1. Viewpack

[7 CANNONBURY LANE - NEW DWELLING - OB SUB FOR 10-05-20.PDF](#)
[30 CANNONBURY - NEW DWELLING - OB REV 10-05-20.PDF](#)
[8 CENTER STREET- FOR OB 10-05-20.PDF](#)

CERTIFICATE OF APPROPRIATENESS

HDC REVISION

1 EAST ELEVATION - FRONT
1/4" = 1'-0"

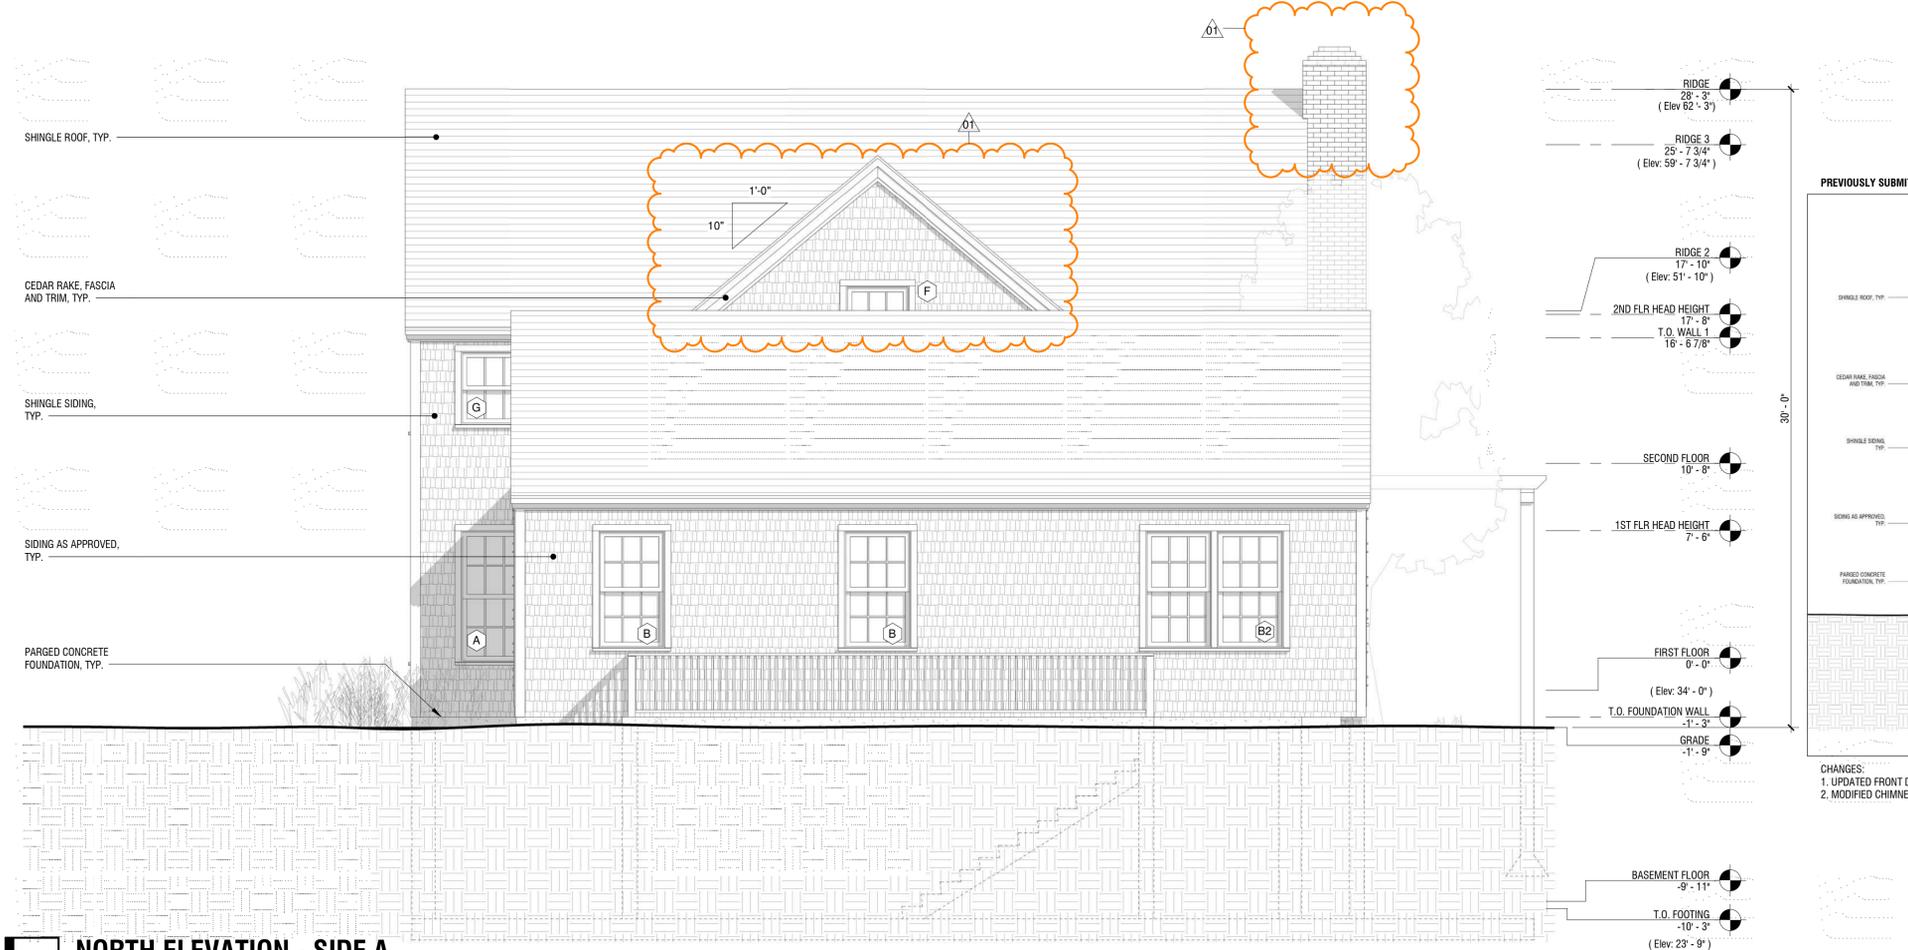
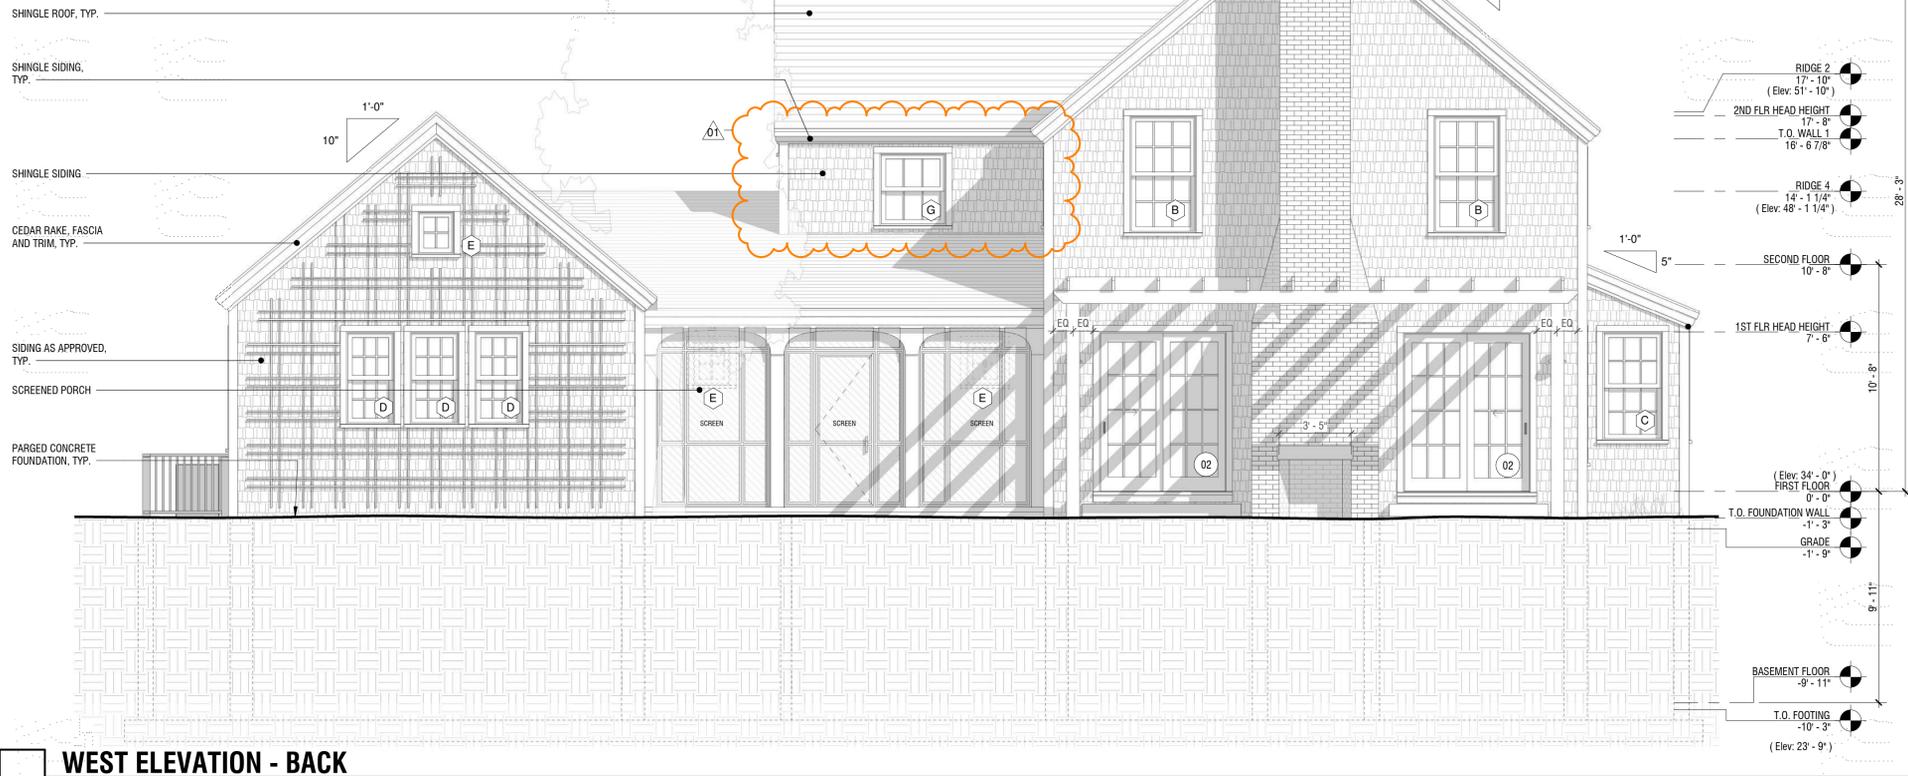
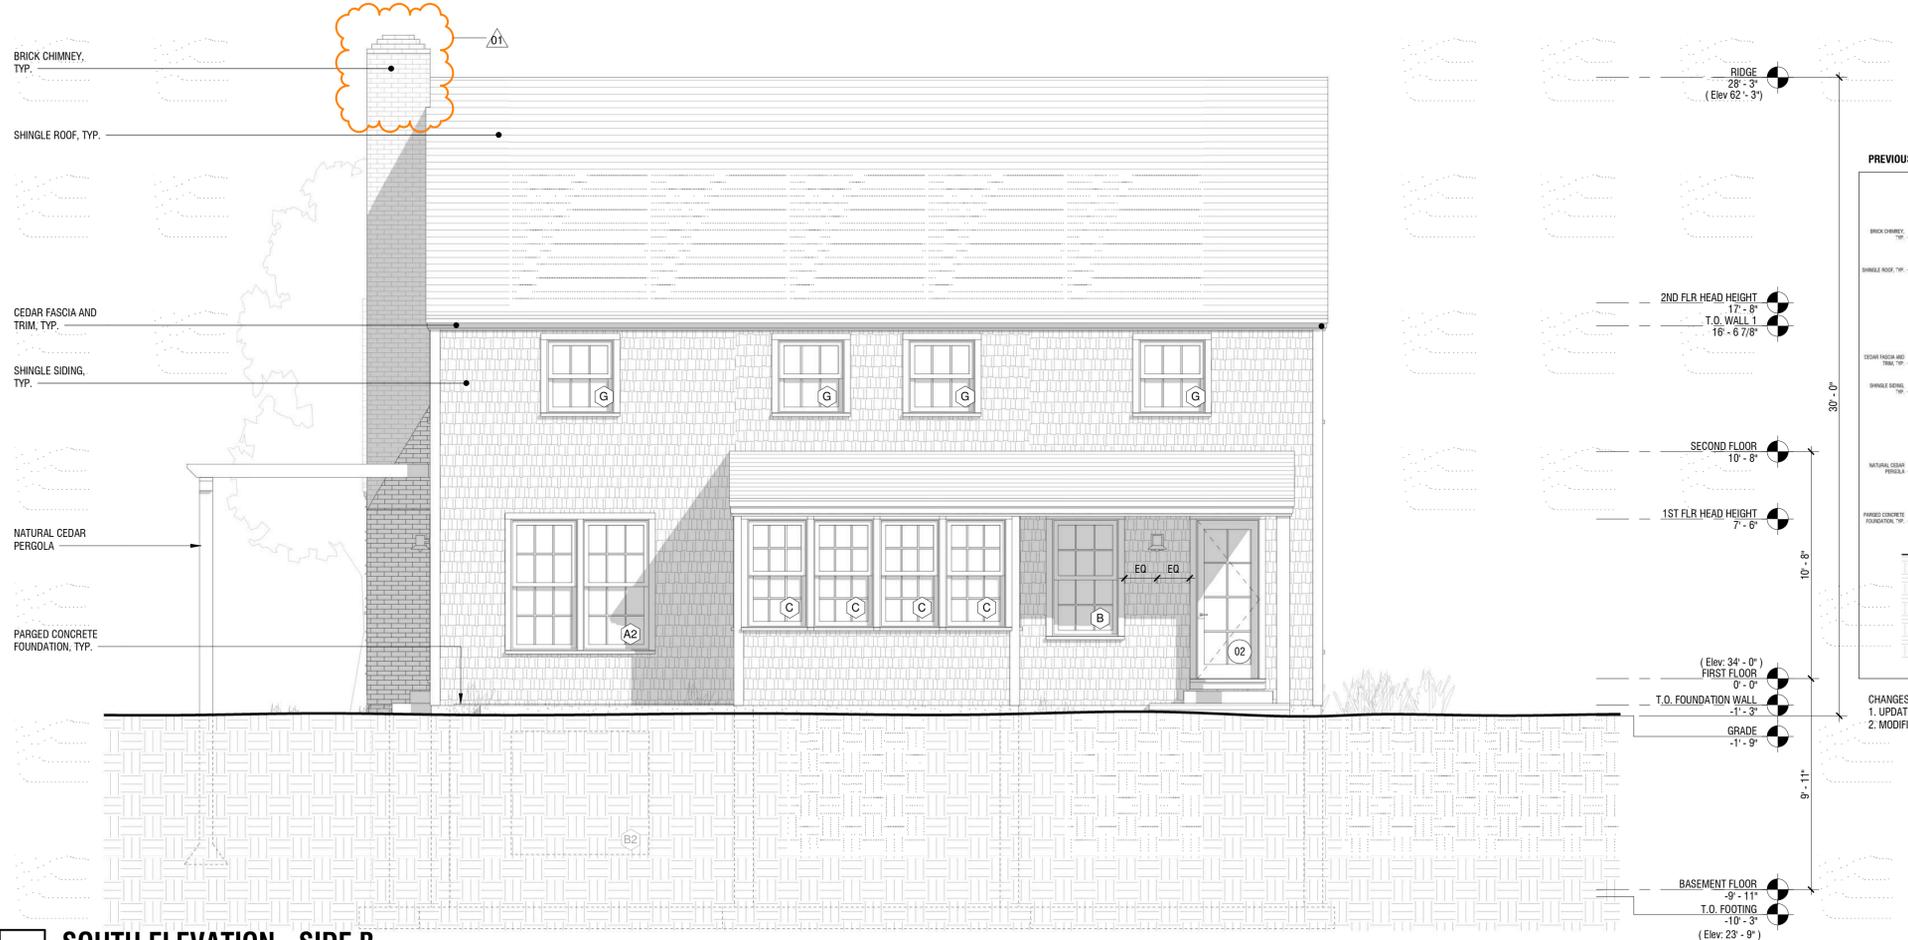
CHANGES:
1. UPDATED FRONT DOOR STYLE
2. MODIFIED CHIMNEY CAP

1 Site Plan
1" = 20'-0"

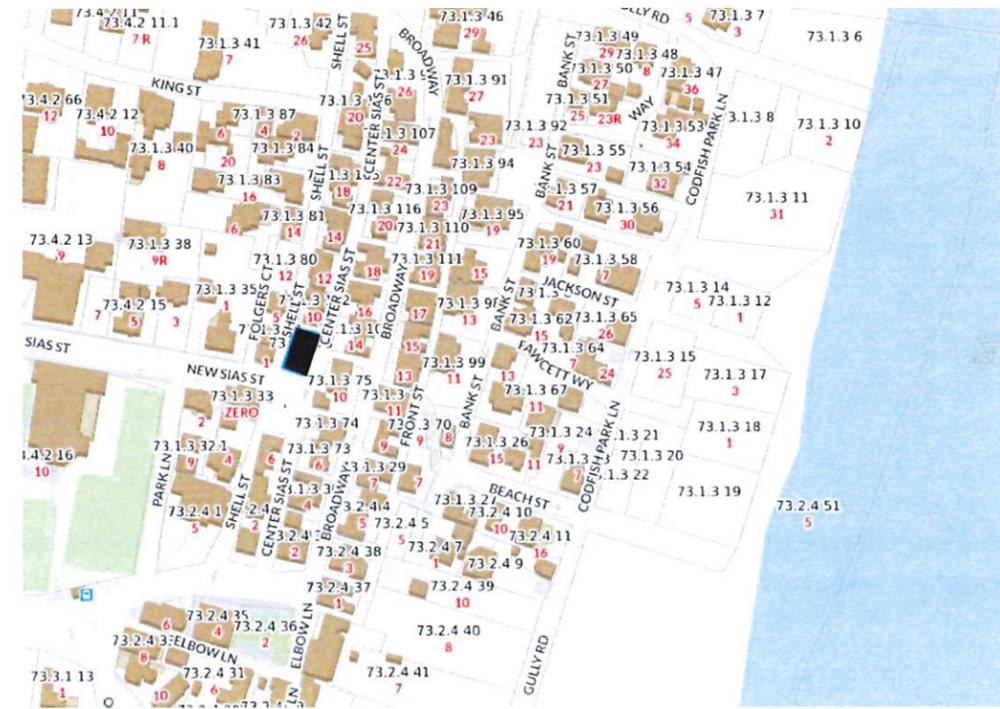
17. Mary O’Connell 08-1508 8 Center Street (Sias) Rev. 12-0352: relocate A/C cond 73.1.3/76 Concept Design
 Voting Pohl, Coombs, Oliver, Welch
 Alternates (Camp still out.)
 Recused None
 Documentation Architectural elevation plans, site plan, photos, historic documentation, and advisory comments.
 Representing T.J. Watterson, Concept Design
 Public None
 Concerns (7:20) **Watterson** – Presented project; to be enclosed in natural-to-weather, cedar lattice.
Backus – Circa 1790. Read SAB comments: A/C might be noisy and visible to visitors in the square; previous location preferred; want to know about screening.
Coombs – Lattice screening has worked well on Shell Street; thinks this will work.
Welch – Given the location, he’d like a detailed drawing in the file showing the lattice enclosure from inside the fence; some of these units need a ground clearance of 10 to 12 inches.
Oliver – She wants to view this.
